McCAULEY™

# SERVICE LETTER

SL2024-2A

C-4044 ADAPTER PLATE ALTERNATIVE

Figure 1. Propeller Adapter Plate Replacement (Sheet 1)

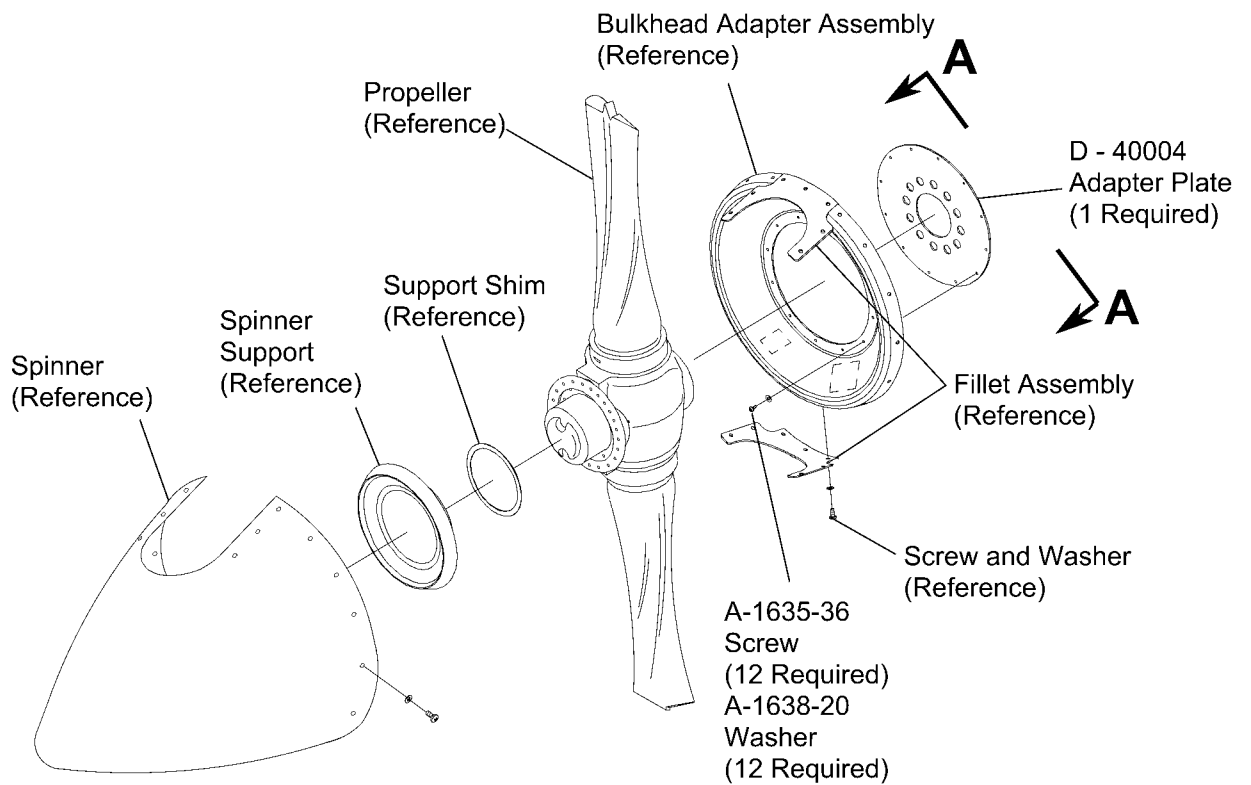
- 4. (Refer to Figure 1, Sheets 1, 2, 3 or 4 depending on the propeller series.) Replace the C-4044 Propeller Adapter Plate as follows:
  - A. Remove the spinner bulkhead from the propeller hub by lifting the bulkhead from the propeller hub studs.

- B. Cut and remove the safety wire from the screws that attach the C-4044 Adapter plate to the spinner bulkhead.
  - C. Remove and discard the screws and washers that attach the C-4044 Adapter plate to the spinner bulkhead.

- D. Install one D-40004 Adapter Plate to the spinner bulkhead using twelve A-1635-36 Screws and A-1638-20 Washers.

**NOTE:** During installation of the adapter plate make sure the flat side of the adapter plate faces forward toward the propeller hub. Make sure to align one propeller hub stud hole on adapter plate with center nut plate on spinner bulkhead. This will make sure the adapter plate attachment holes are aligned correctly.
  - (1) Torque the screws to 23.0 (± 3.0) inch pounds.
  - E. Safety wire the twelve A-1635-36 Screws in pairs of two (double twist method) using MS20995C32 Safety Wire.
  - F. Install the spinner bulkhead onto the propeller hub studs.

Figure 1. Propeller Adapter Plate Replacement (Sheet 4)

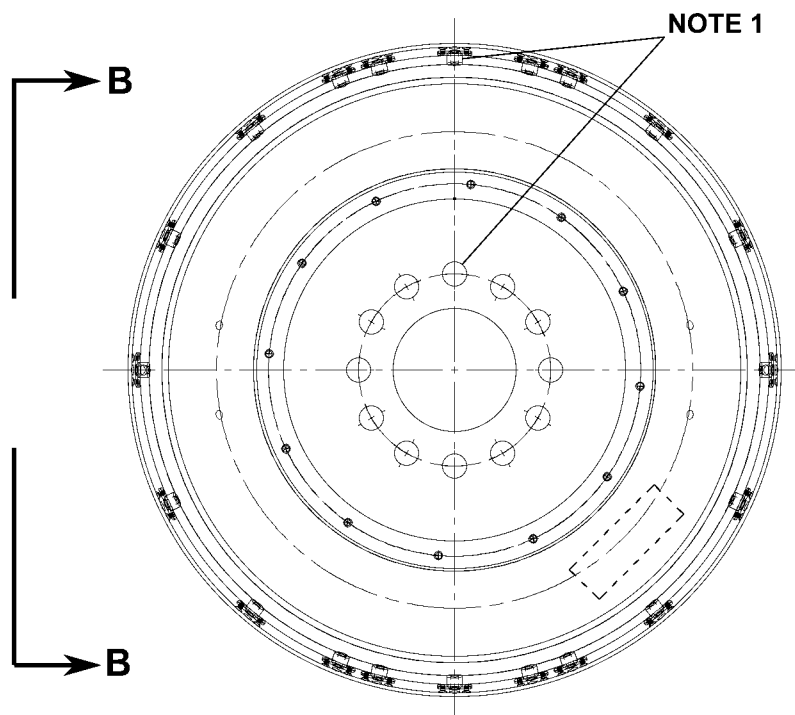
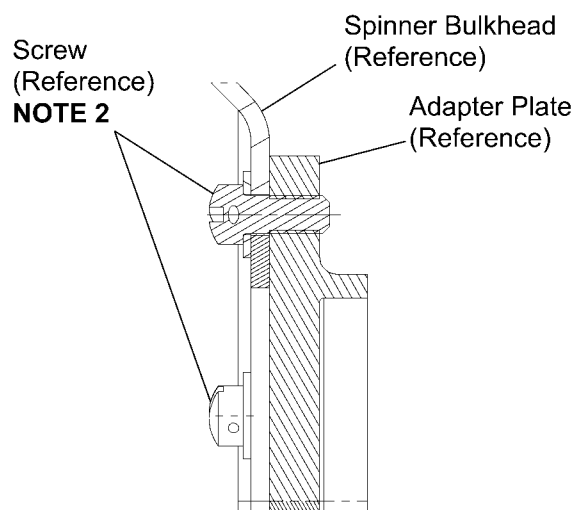
**NOTE 1:** Align the stud hole with the center nut plate on the spinner bulkhead.

**NOTE 2:** Safety wire the screws in pairs (two) using MS20995C32 Safety Wire.
